SQUEAKY SHINE CAR WASH JSP18-55

Consideration at the request of Squeaky Shine LLC for Preliminary Site Plan and Storm Water Management Plan approval for site improvements to expand the existing car wash facility at 21510 Novi Road. The property is in Section 35, located on the east side of Novi Road between Eight Mile Road and Nine Mile Road, and is zoned B-3 (General Business). The subject property is approximately 1.56 acres.

Planning Review

APPLICANT RESPONSE LETTER

DRAWN BY: JC
CHECKED BY: -
PROJECT MANAGER: MMC
JOB #: 17033582
FILE CODE: CP
SHEET NO. **C01**

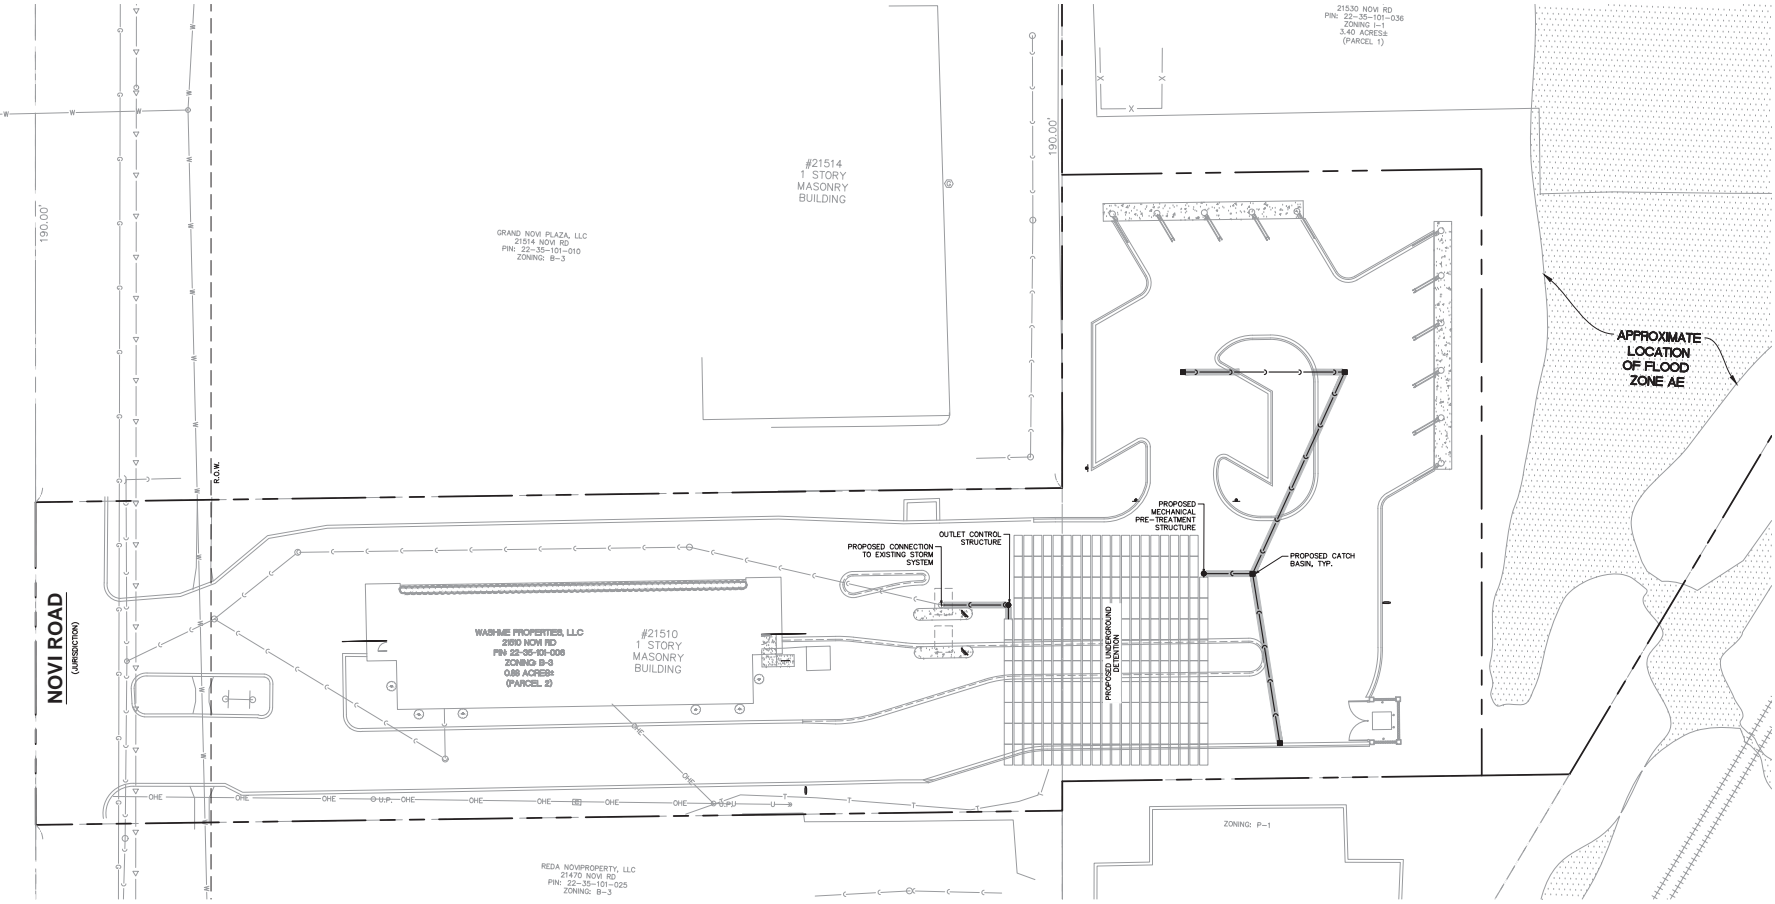
- a. Relocating the proposed loading area to a suitable location within the rear yard, subject to Traffic consultant approval at the time of Final Site Plan approval;

3. **Loading Area (Section 5.4.1):** Loading/unloading space is required to be located in the rear yard at a ratio of 10 square feet for each front foot of building (44 ff of building x 10 sf = 440 sf required). The applicant shall show the required loading zone on the plans or provide justification to support not providing one. The absence of a loading/unloading area would require a Zoning Board of Appeals variance. *Update 6/10/19: A 10 foot by 44 foot loading zone is now shown on the north side of the building in the rear yard, with a notation that all deliveries will take place after hours. The placement of the zone in the 18-foot drive aisle would potentially only leave 8 feet of the aisle clear when a delivery vehicle is present. If the deliveries are to be restricted to after the hours of operation, the loading area could be located within the drive-through queuing area and not block the drive aisle, which would allow emergency equipment to access the site. The applicant should provide a statement indicating the hours and frequency of deliveries and the size of the typical delivery truck serving the site.*

- **Loading area will be relocated to the drive-through area on the Final Site Plans.**
- Parcel combination must be completed before final stamping set approval.

DRAWN BY: JC
 CHECKED BY: -
 PROJECT MANAGER: MMC
 JOB #: 17033582
 FILE CODE: CP
 SHEET NO. **C03**

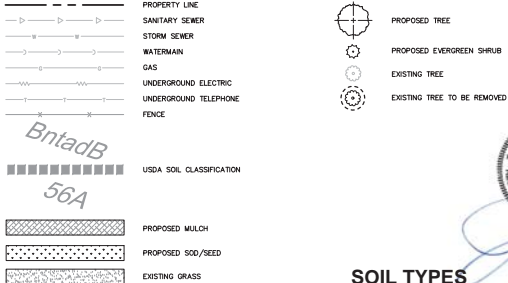
1. **Based on the vehicular use area, 1203sf of interior landscape islands and 6 canopy trees are required. 2525 sf and 6 trees are provided.**
2. Based on the parking/vacuum area perimeter and access way perimeter, a total of 31 canopy trees are required. 28 canopy trees and 8 subcanopy trees, beneath the overhead utility lines on the south side of the property, are provided. Only 5 subcanopy trees are required, so 3 can be removed from the plan if desired.

1. Provided
2. **Please add a tree protection fence detail and show tree fencing to protect all trees to remain.**
3. **Please add the anticipated dates of landscaping installation on the landscape plan.**

- **Tree location will be revised on the Final Site Plan Submittal.**
- There is an existing healthy tree on the adjacent property to the north that does not appear on the survey. Please place the new tree such that it is not damaged or crowded by the new tree.

- **No new hydrants are proposed.**
- Please move all perimeter trees to within 15 feet of the curb.
 - **Perimeter trees will be located within 15' of the curb. Changes will be reflected on the Final Site Plans.**

- You can remove 3 subcanopy perimeter trees from the plan if desired, but please spread the remaining trees out fairly evenly to provide maximum shading along the access drive.

- **Tree location will be revised on the Final Site Plan to ensure ample separation from the existing tree.**
- If any hydrants are required on site, please be sure to provide at least 10 feet between hydrant and trees.

- **3 sub-canopy trees will be removed and the remaining trees will be spread as evenly as possible as requested. Changes will be reflected in the Final Site Plans.**
